Application for Disposal System Construction Permit

Plan Date 10/19/96 Number of sheets 10 Revision Date _____
 Title SEWAGE DISPOSAL SYSTEM FOR RUSSELL KOTFILA

Re: Variance request for a failed septic system at 388 Middle Street Amherst, Massachusetts.

TITLE 5
OFFICIAL INSPECTION FOR - NOT FOR VOLUNTARY ASSESSMENTS
SUBSURFACE SEWAGE DISPOSAL SYSTEM FORM
PART A
CERTIFICATION

Septic System Profile

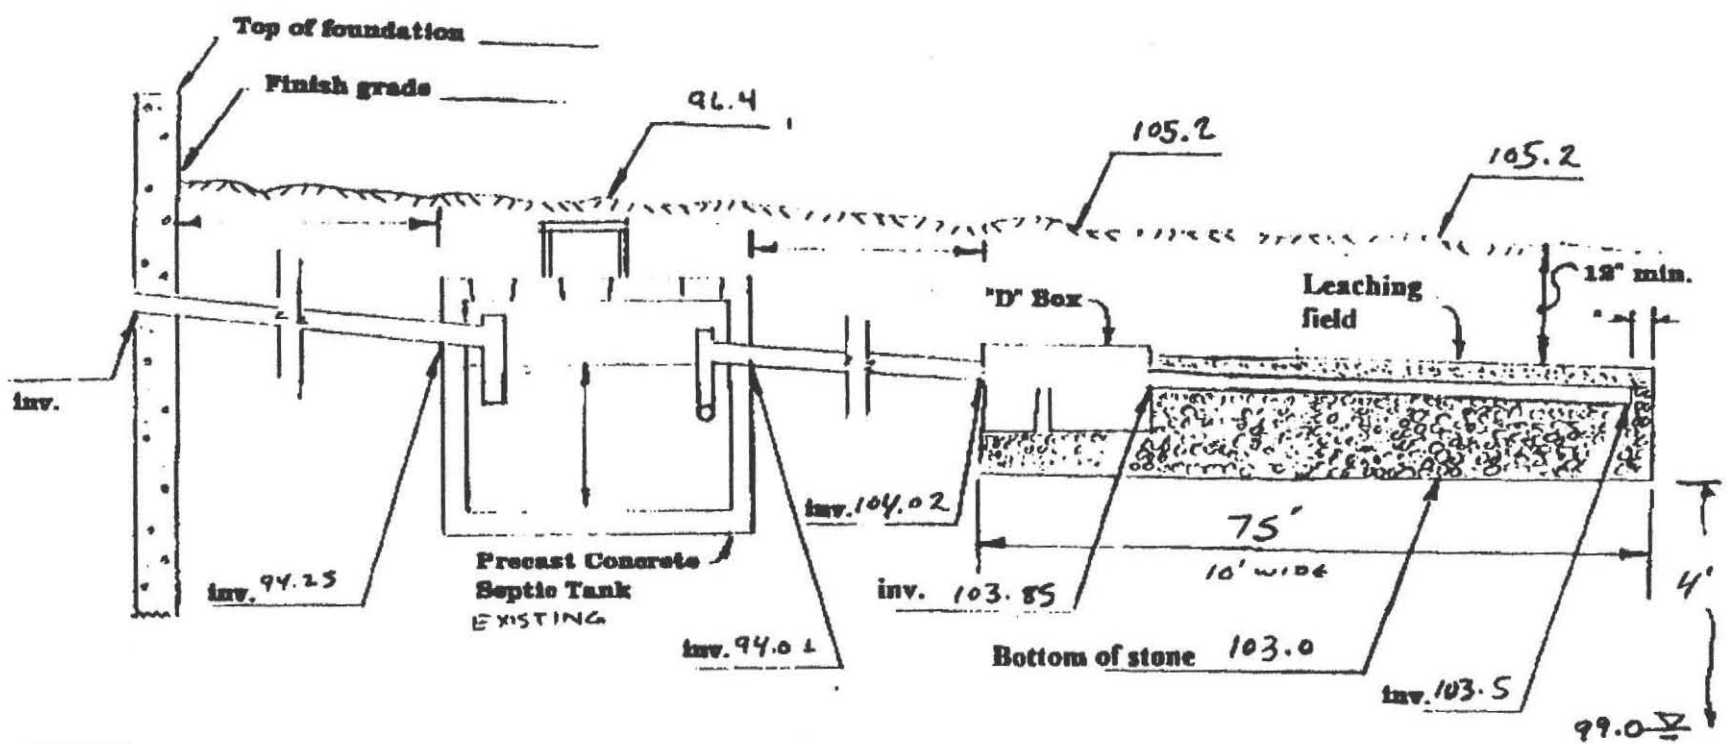
all PVC outlet baffle
h 4" tee as gas deflection
file in existing septic tank.
